Subject: Addendum to Revised IRM-1 Work Plan– Acid Neutralization Systems Removal  
Former Philips Lighting Company Bath Site  
BCP Site # C851044

**EXCAVATION PLAN**  
IRM-1

**SAMPLING AND ANALYSIS PLAN  
IRM-1**

**FIGURE 4**

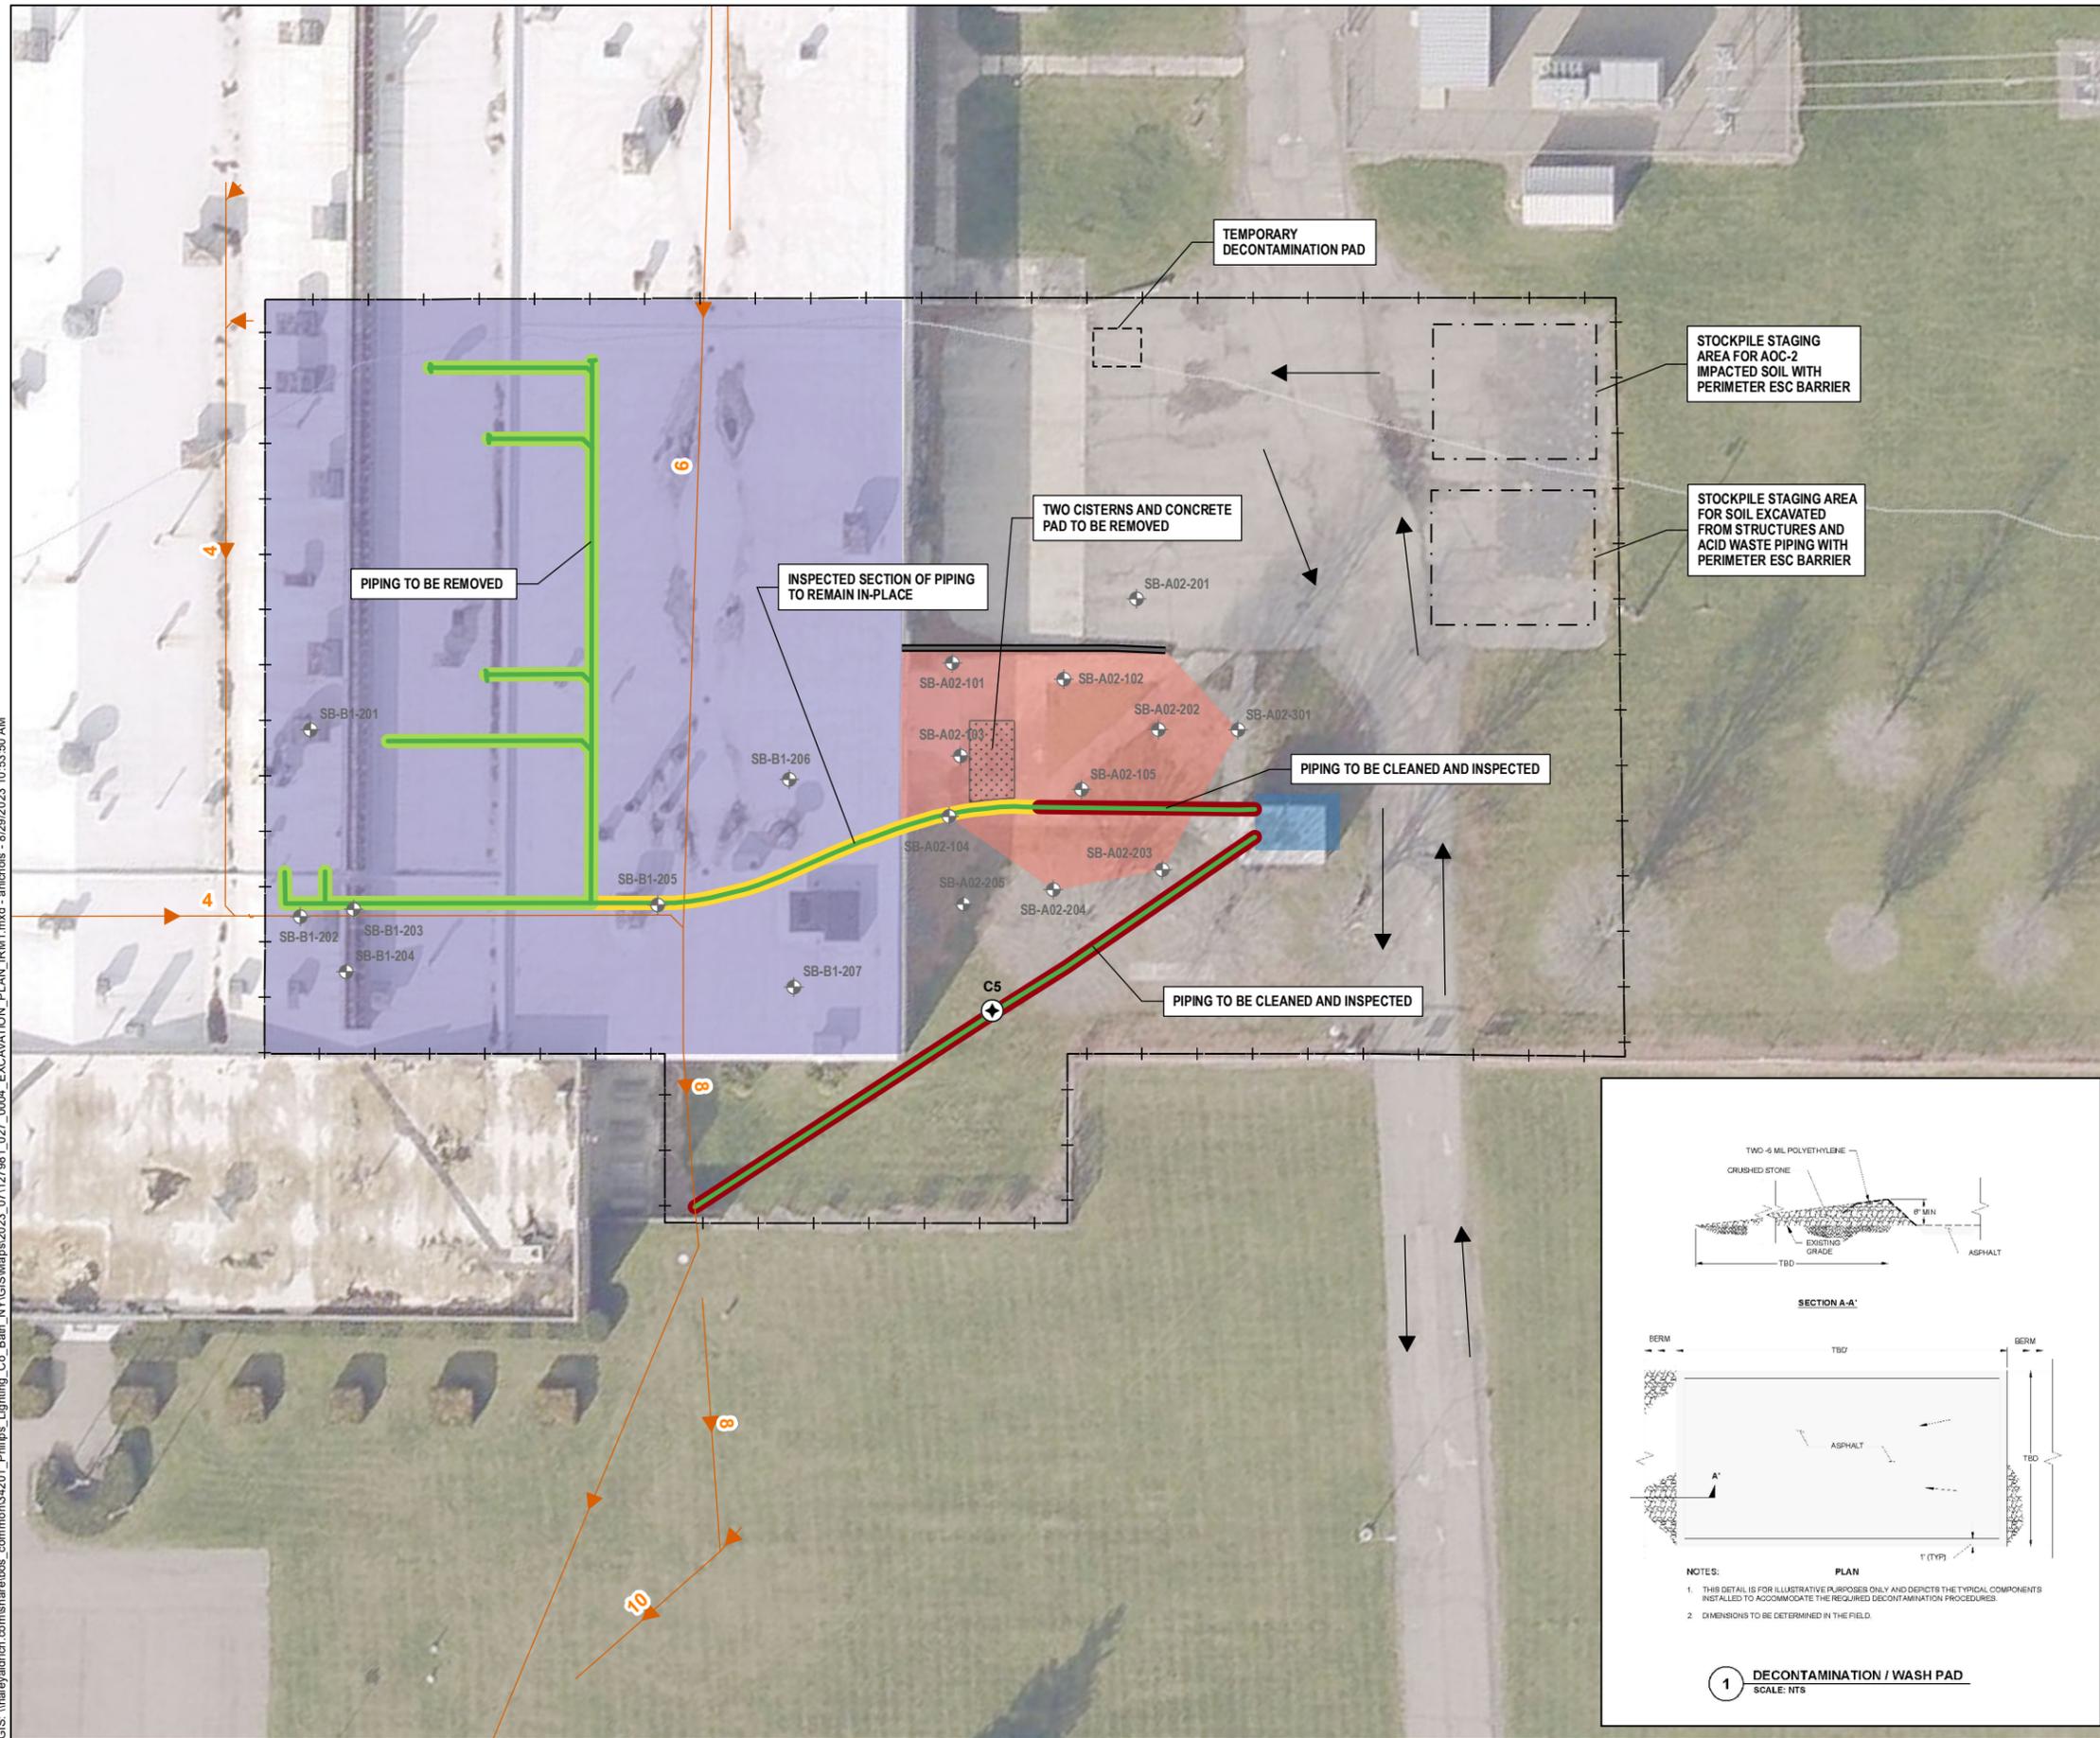
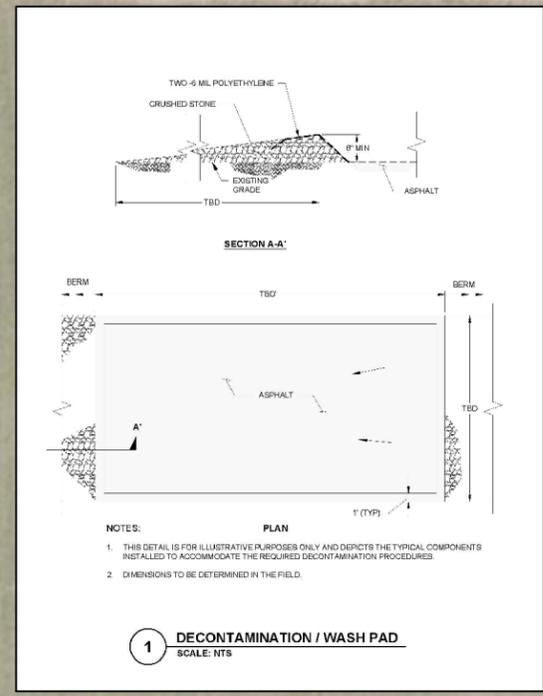
***NYSDEC Comment No. 2:*** Please provide construction details on the proposed decontamination pad and rinse containment.

**Yort Response No. 2:** Acknowledged; an updated Figure 4 showing the construction details of the proposed decontamination pad and rinse water containment is enclosed with this addendum as an attachment.

FIGURE 5

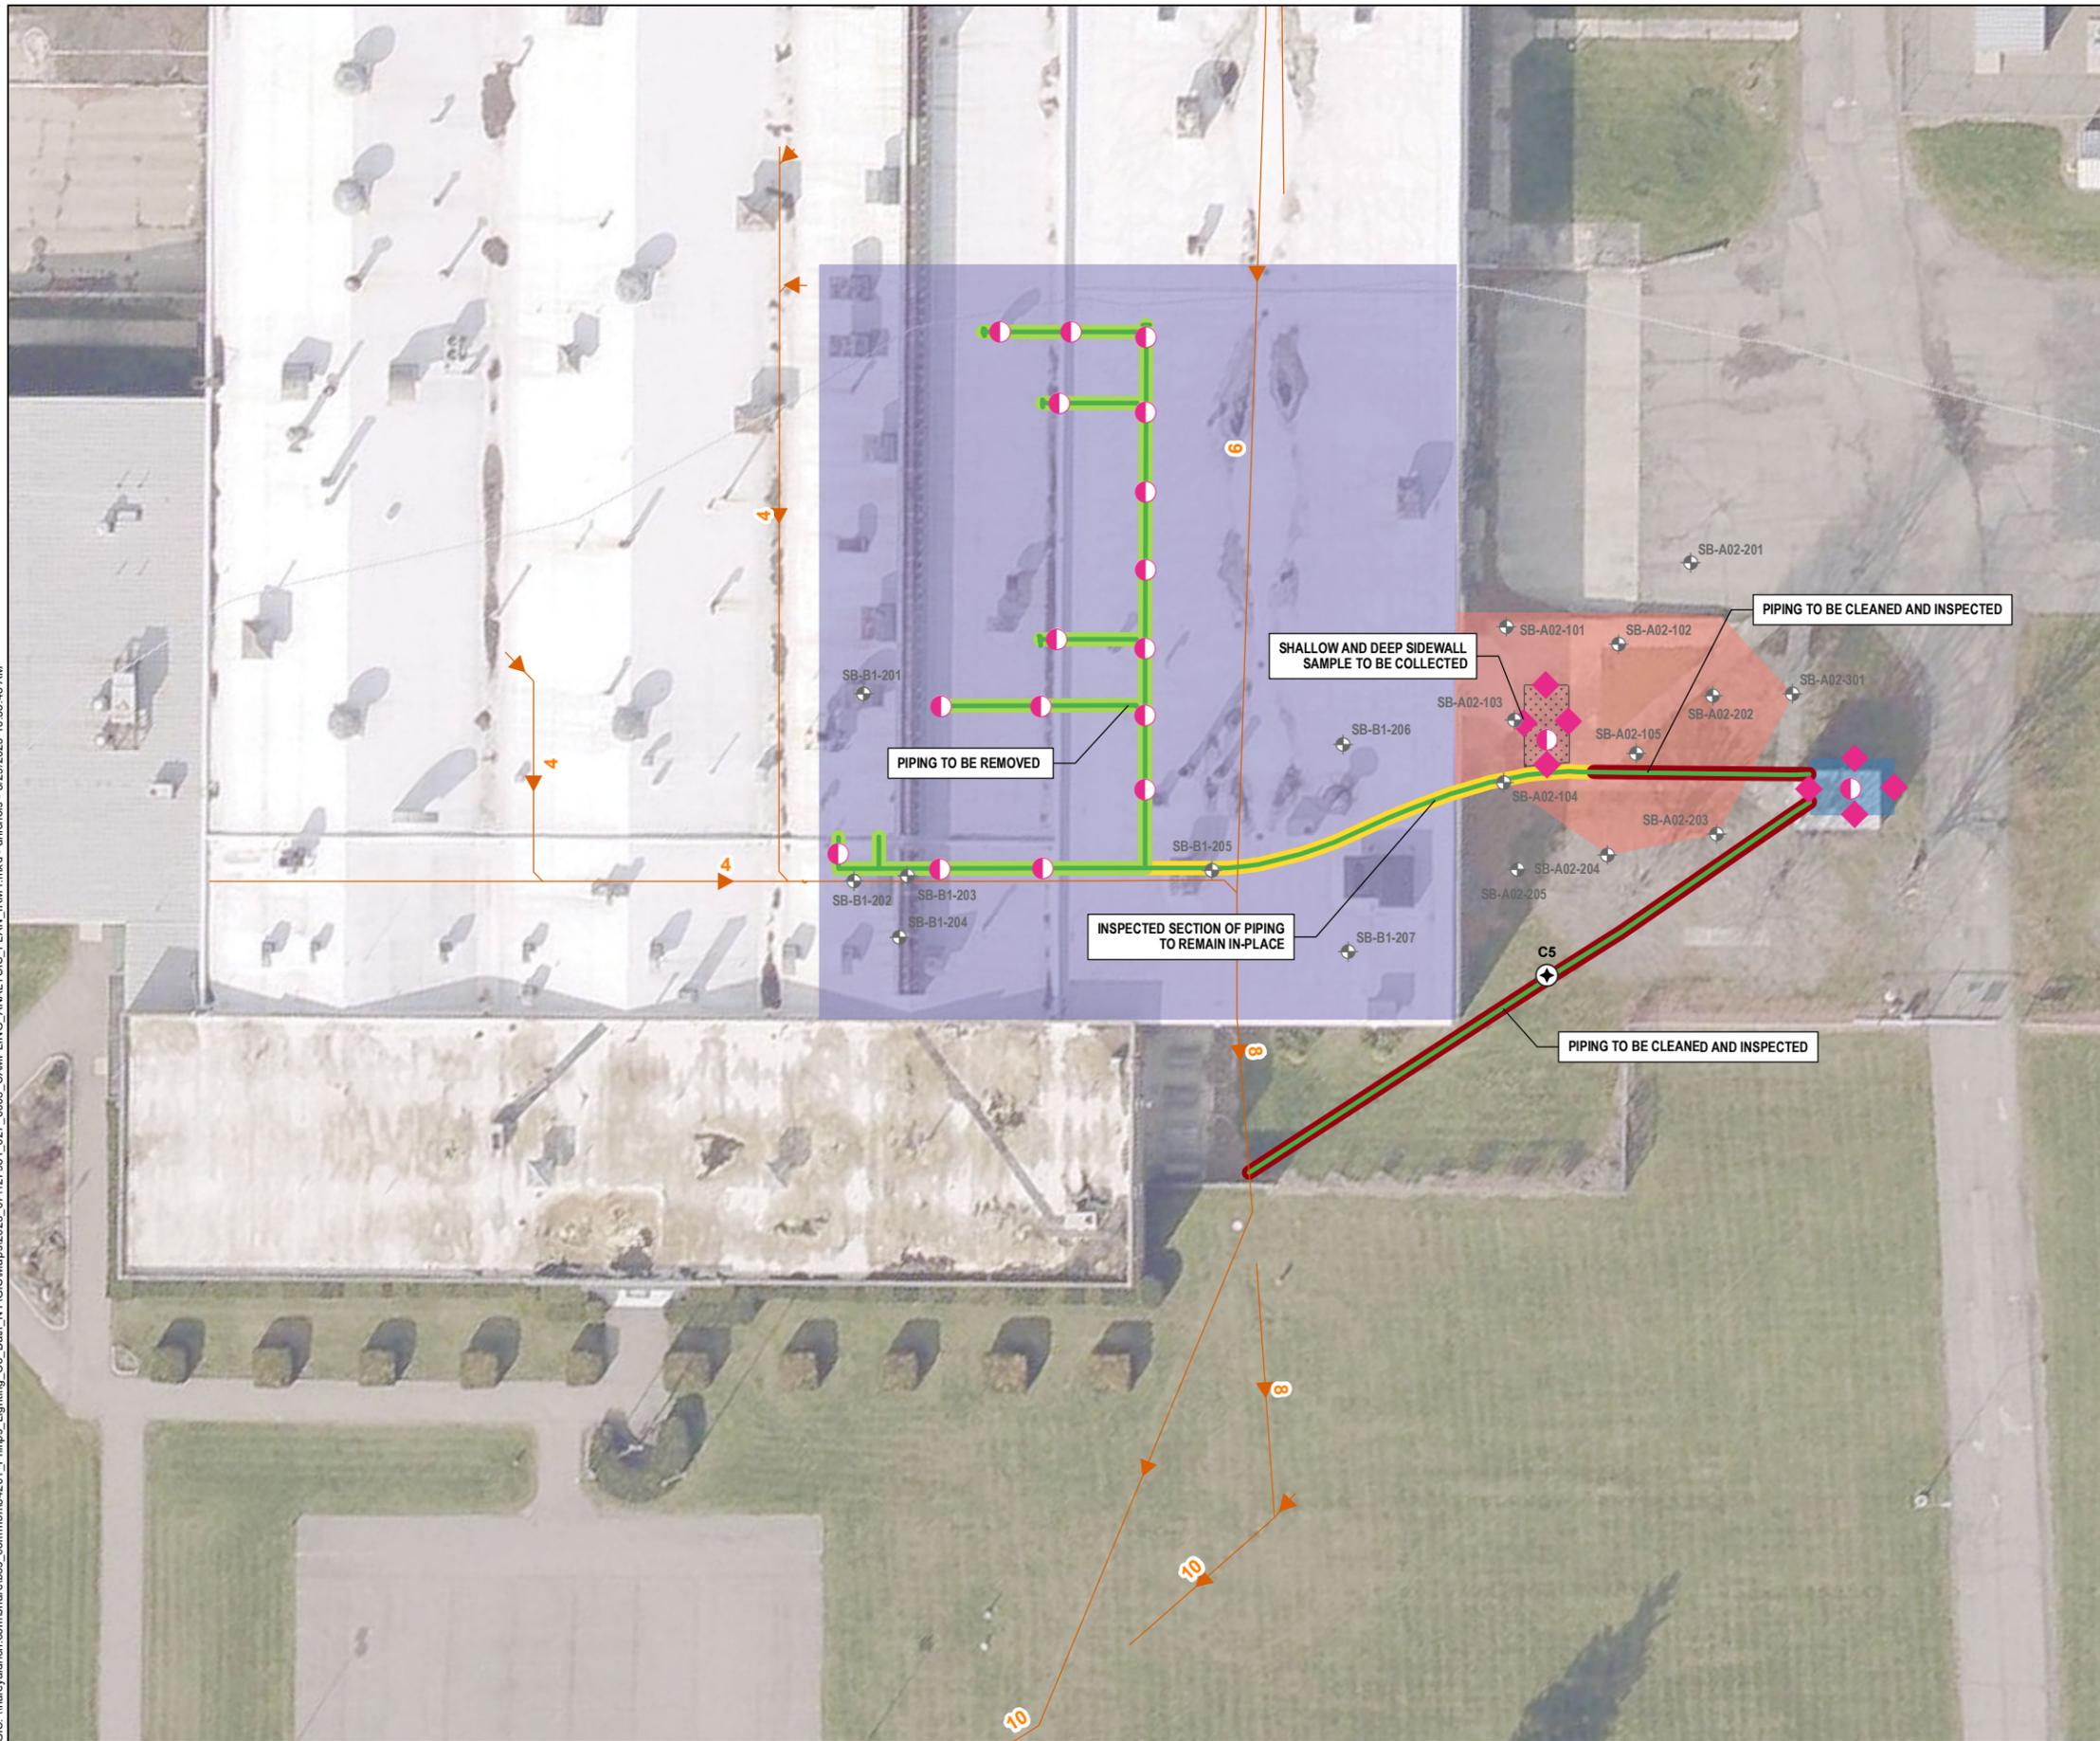
***NYSDEC Comment No. 4:*** The Department understands that a portion of the concrete slab, as outlined on figure 5, is planned to be removed concurrently during the IRM-1 work. The Department also understands that, per figure 5A, a cover system is only planned to be installed in specific areas of removal. If a cover system will not be installed in other areas, then the newly exposed soils need to be characterized and assessed for contamination as well as their ability to support vegetation. This work may be handled separately as a notice under the Excavation Work Plan of the Interim Site Management Plan provided the notice is submitted and approved by the Department prior to initialization of this work.

**NYSDEC Comment No. 5:** *During a soil removal, sidewall samples need to be collected from all four sidewalls and a sample from the “floor” of the excavation. On figure 5, it appears only two sidewall samples (east and west) are proposed. Please include samples on the northern and southern sidewalls as well, as depicted for the acid neutralization building.*

**Yort Response No. 4:** Acknowledged; seven surficial (samples collected immediately beneath the building slab at depths of 0 to 1 foot) were collected and analyzed for the expanded list of analytical parameters during the interior sub-slab soil investigations of Building 1 in this area, and soils did not contain constituents above NYSDEC Industrial SCOs. In addition, 16 samples along sections of the piping

**Yort Response No. 5:** Acknowledged, we have included additional sidewall samples to be collected from the water cistern excavation as shown on revised Figure 5 (attached). This will include at least one sidewall sample for each face of the excavation. It will also include both a shallow and deeper sidewall on the southern face of the excavation in response to our response to NYSDEC Comment No. 3 regarding the mercury present in this area at a depth of 1 to 2 feet below grade.
